# Errata Sheet

**Product Family:** DL405 **Date:** December 11, 2018  
**Manual Number:** D4-USER-M  
**Revision and Date:** 4th Edition, Rev. A; March 2013

### Reset the PLC to Factory Defaults

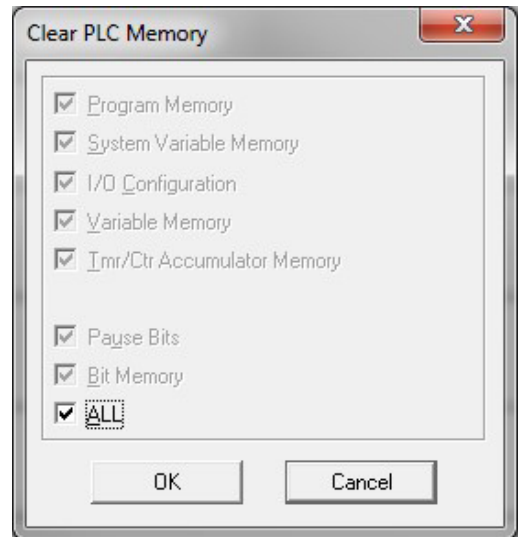
Page 9-26. Add the following to the end of this chapter (right after BREAK Instruction placement):

Step 1 – While connected to the PLC with DirectSoft, go to the PLC menu and select; “Clear PLC Memory”. Check the “ALL” box at the bottom of the list and press “OK”.

Step 2 – While connected with DirectSoft, go the PLC menu and then to the “Setup” submenu and select “Initialize Scratch Pad”. Press “Ok”.
